US.1 PEDESTRIAN OVERPASS STUDY

January 26th, 2000
July 7th, 2000 - Revised

MCHARRY ASSOCIATES

RE: City of South Miami, Pedestrian Overpass
At South Dixie Highway (US-1) near Sunset Drive

DRAWING TITLE:
SCHEME "A" - PLAN

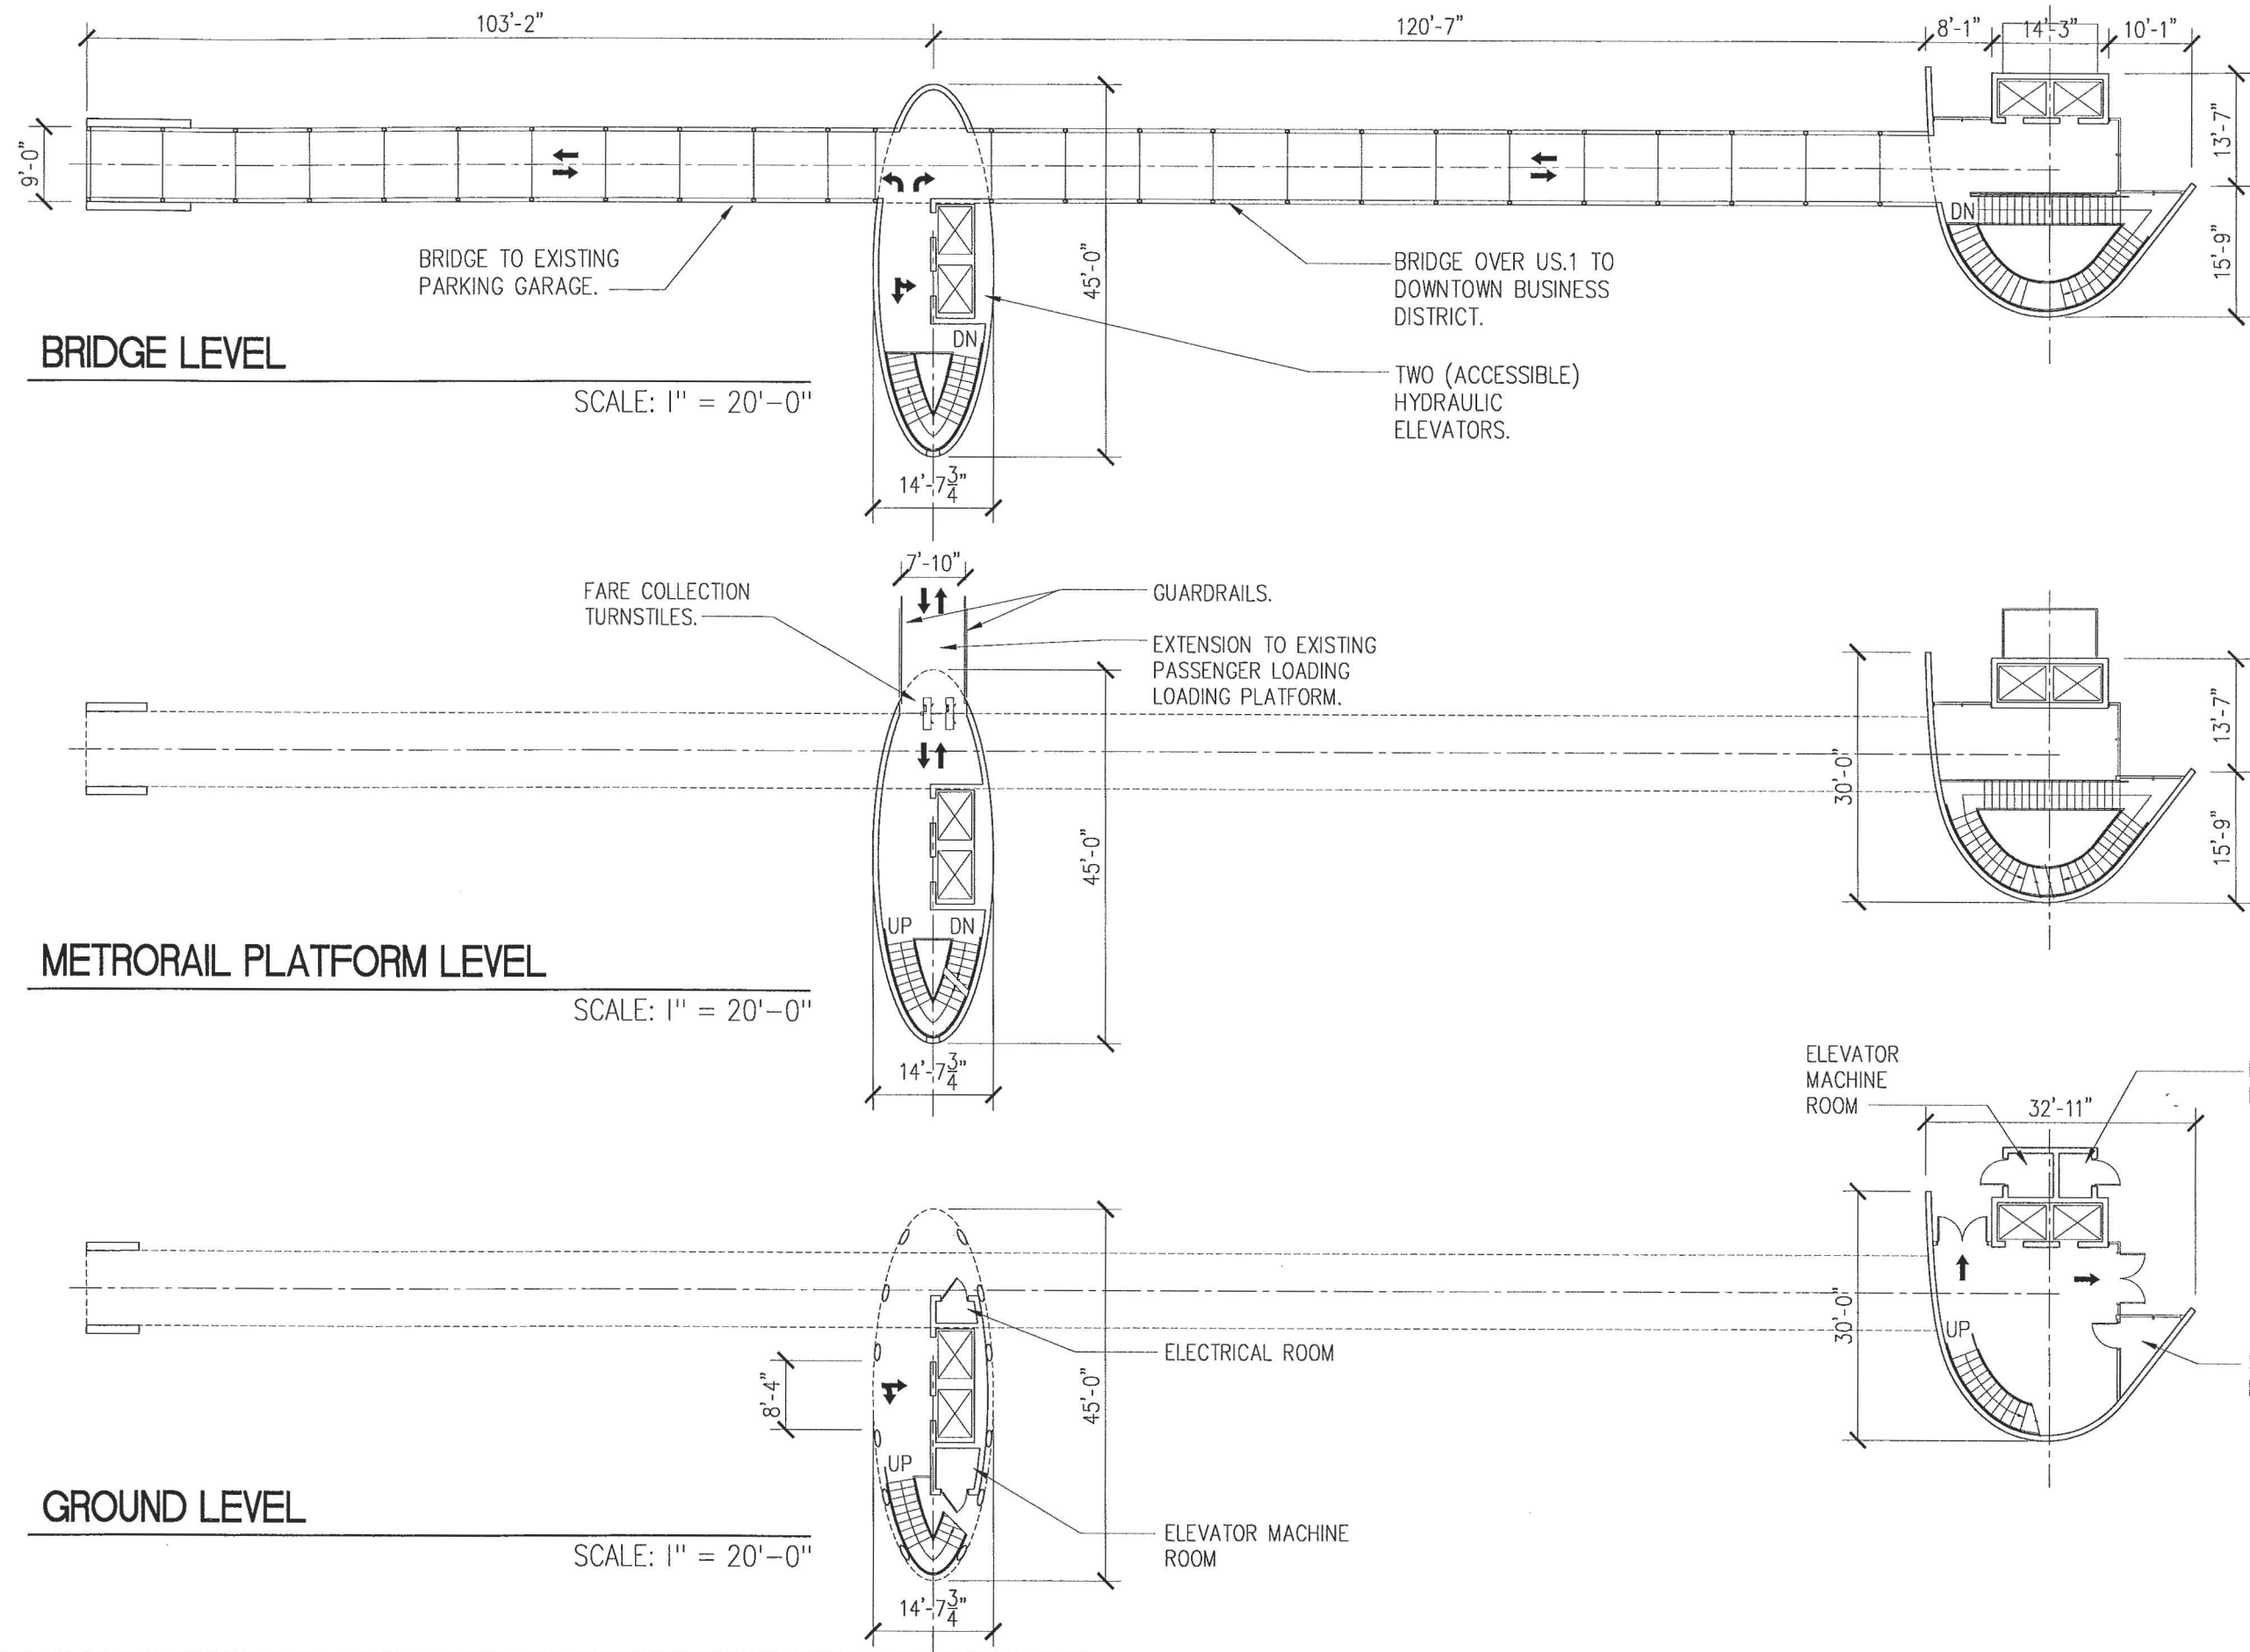
- Scheme "A" in Sheet A-1 and Scheme "B" in Sheet A-2 seem to meet FDOT criteria for horizontal and vertical clearances.

DRAWING TITLE:
SCHEME "C" - PLAN

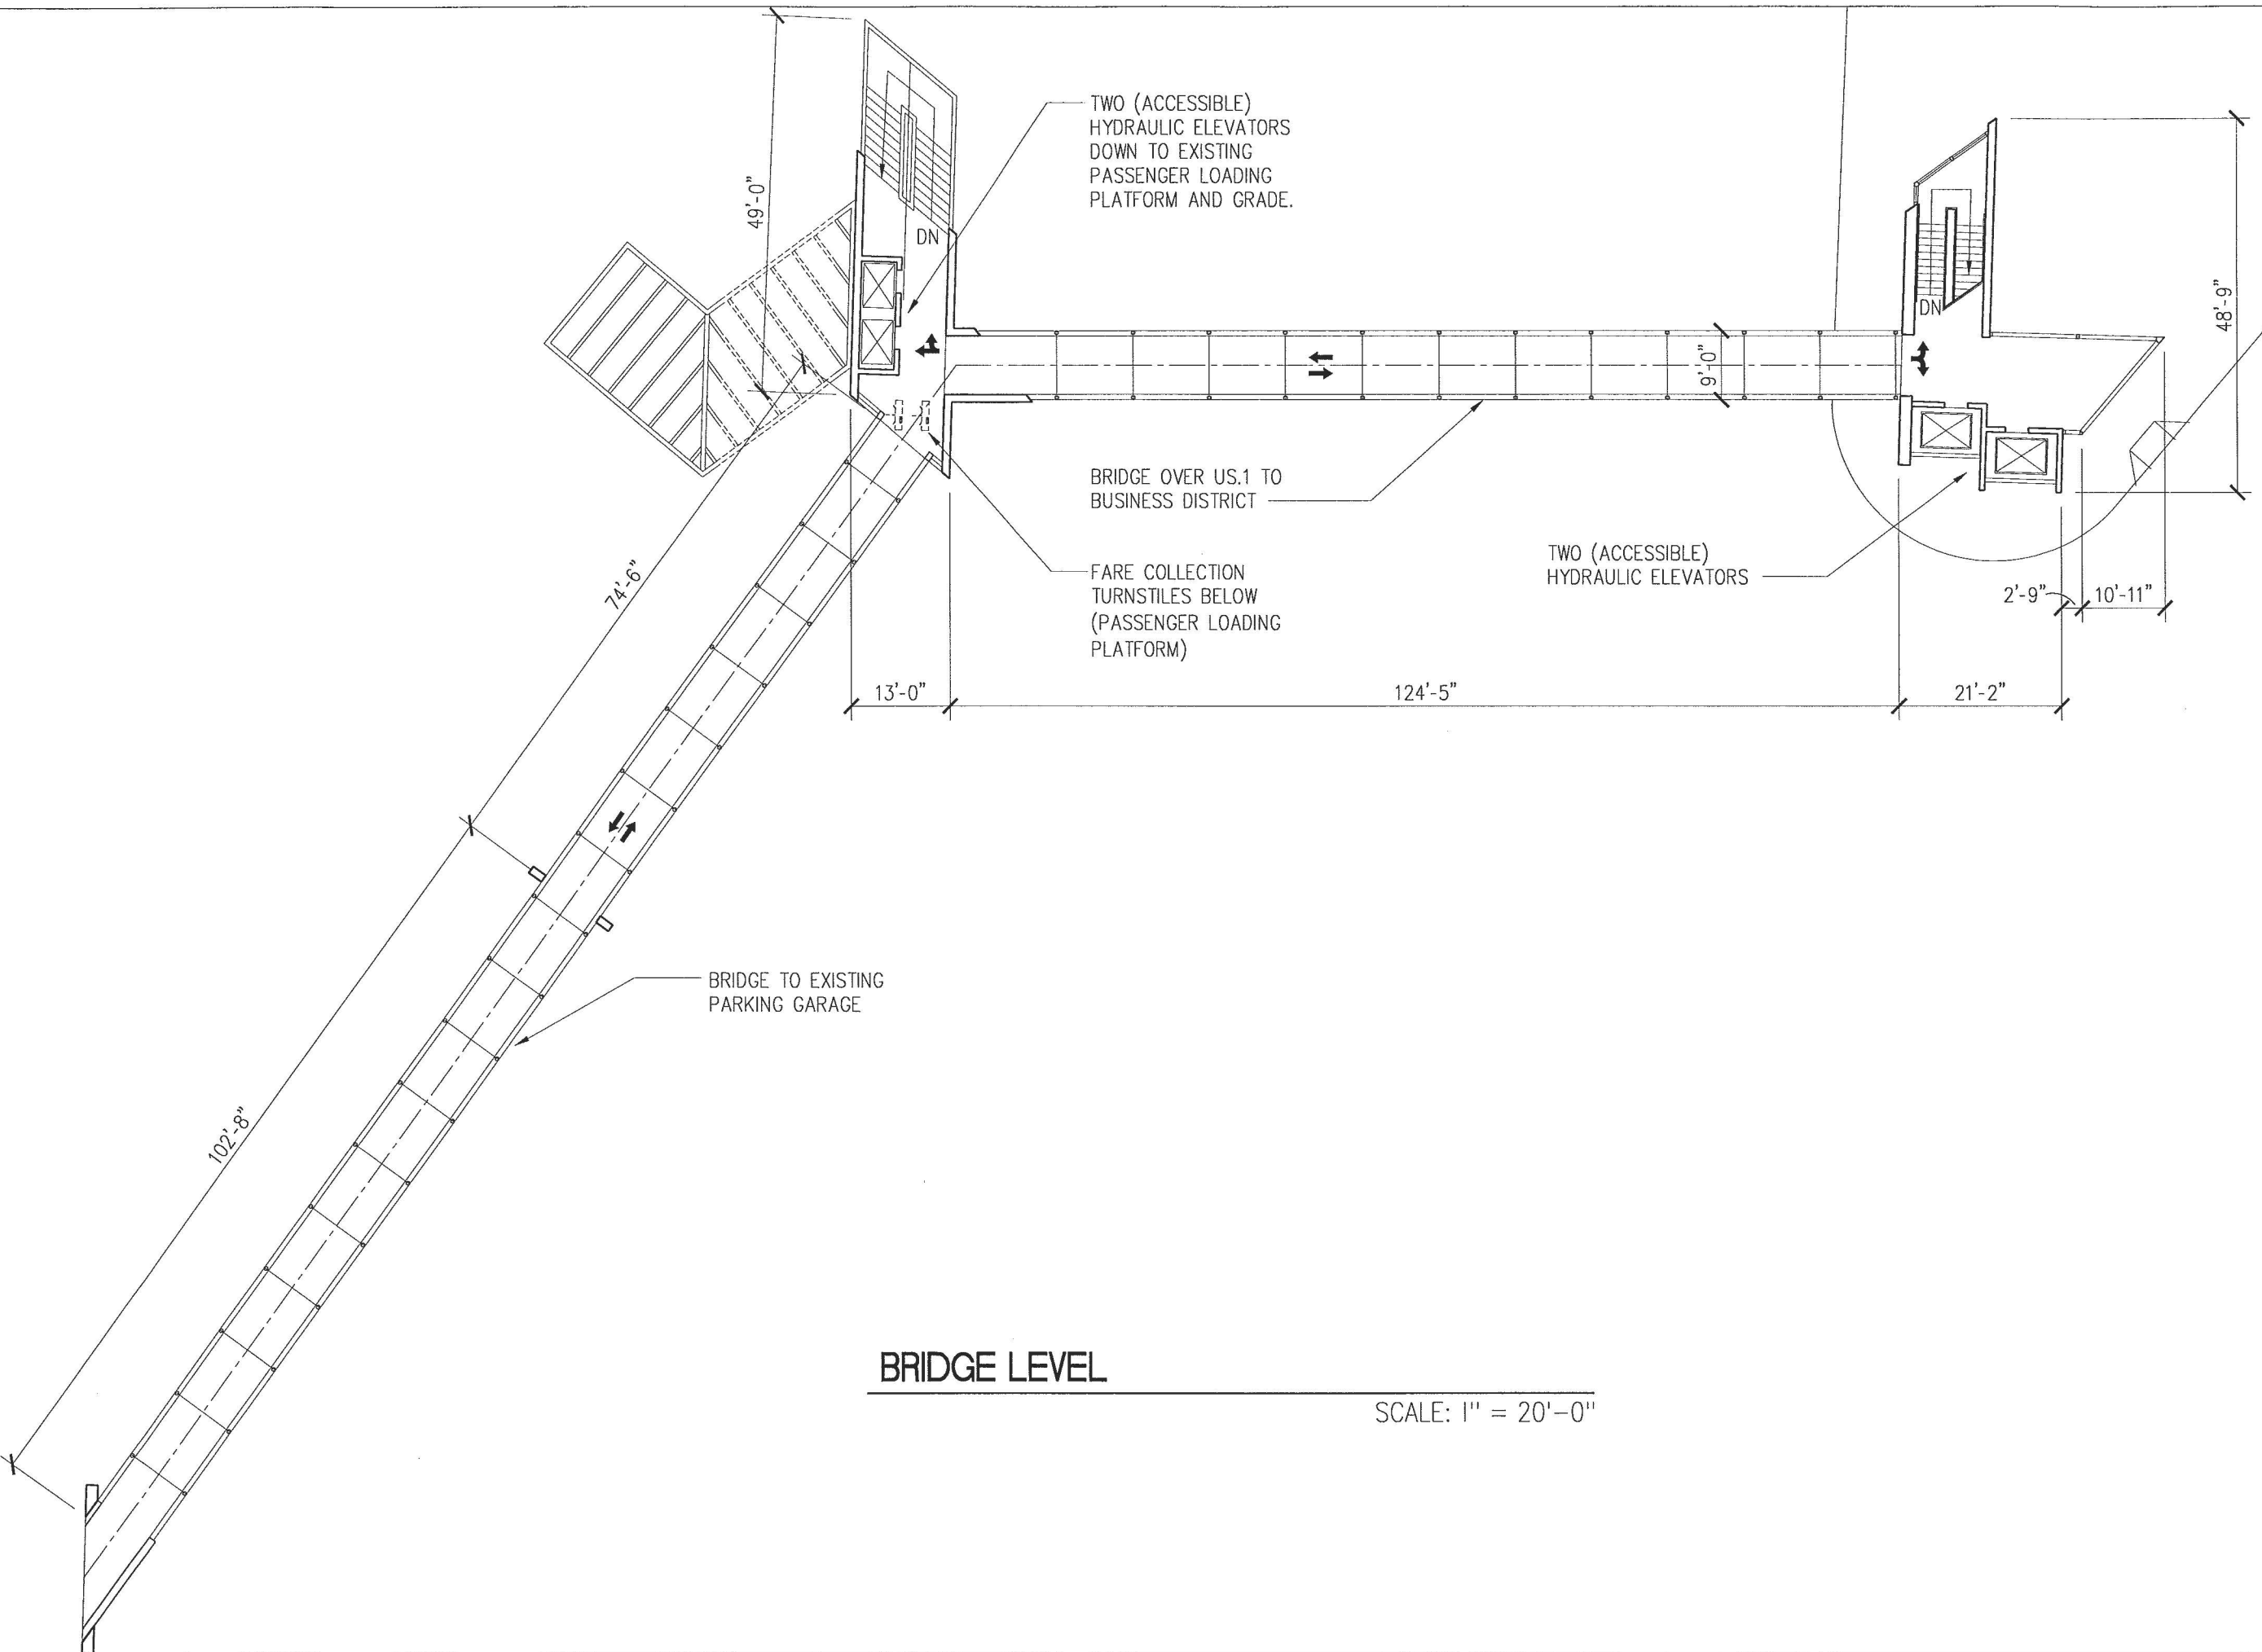
- Scheme "C" in Sheet A-3 does not appear to meet FDOT required horizontal clearance at the center support. In addition, we foresee a major disruption of traffic on South Dixie Highway during the construction of this center support. We recommend that this scheme or any others with intermediate support in the median of South Dixie Highway, are not considered in your study.

p. 8 Scheme C - Paragraph 1 says that the bridge will require support in the US 1 median. I believe that is an error, since the schematic for C does not show that, nor do I remember any mention of it during any meeting or discussion.

Figure 2.10.4 Clearances

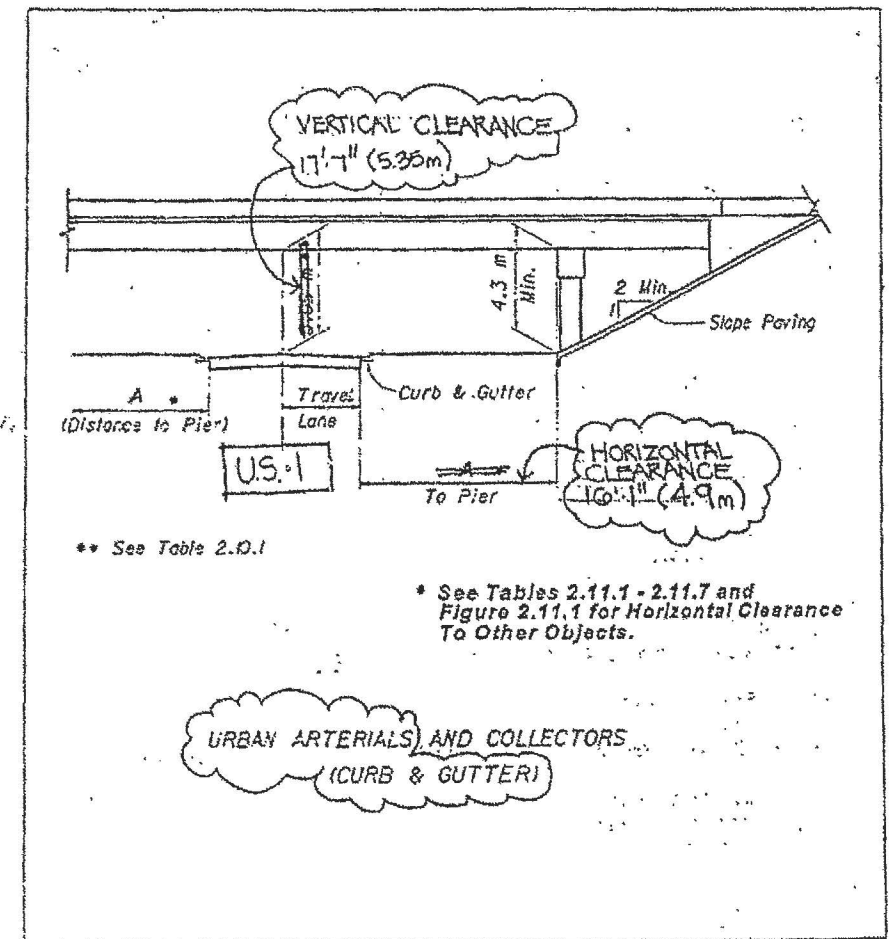
Dear Mr. Forti,
Per our conversation last week, the following represents our findings for the dimensional criteria regulating the pedestrian overpass at the South Miami MetroRail station and US-1. The two basic requirements are:

- Minimum vertical clearance 5.35m (17'-7") Table 2.10.1
- Minimum horizontal clearance 4.9m (16'-1") Table 2.16.6

Please review the attached sketch illustrating these clearances and make any necessary comments or corrections.

With reference to your memo of 3/15, please be advised that the clearance criteria shown therein is correct.

Lou:
THE CRITERIA SHOWN ABOVE IS CORRECT. PLEASE FIND THE ATTACHED COPY OF CHAPTER 14 OF THE STRUCTURES DESIGN GUIDELINES FOR YOUR INFO. IN MY OPINION, THE APPROACH RAMP IS REQUIRED FOR CHILDREN AND HANDICAPS OR SENIOR CITIZEN. A COMBINATION OF STAIRS AND ELEVATORS SHOULD DO THE JOB.
